Access Compliance Report

Public Rights-of-Way

(Curb Ramps)

| Intersection ID: 10559 | Main Street: CHARLES_AV | Cross Street: E_35TH_ST | Location: E |

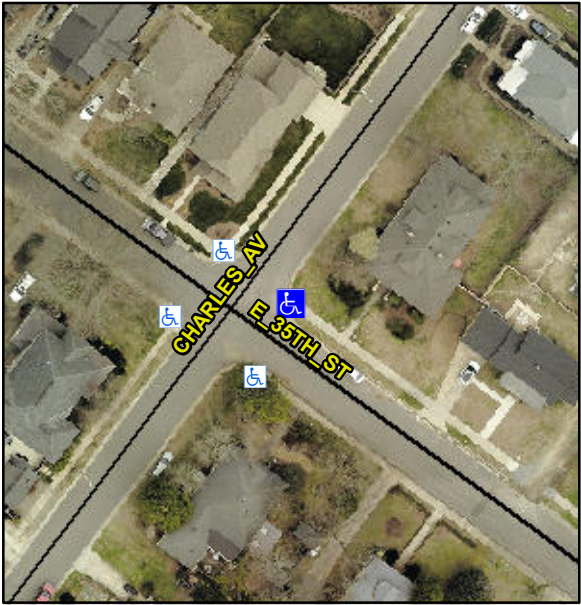
| ADA ID: 2A2E39EEABA6 | Ramp Type: Perp | Initial Pass/Fail: Fail | Overall Compliance: No |

| Codes/Mitigation Info/Possible Solution | | | Field Measurements/Component Compliance | | |
|---|--|------------|---|-----------------------------|-------------|
| | Remove & Replace Entire Ramp. | | No | Ramp Length (in) | 71.5 |
| | | | No | Ramp Width (in) | 46.0 |
| <p>Surveyor Notes:</p> <p>N/A</p> <p>PROW/ADA:</p> <p>Not Found, R304.5.1, R304.2.2</p> | | | N/A | Flare Type RT | N/A |
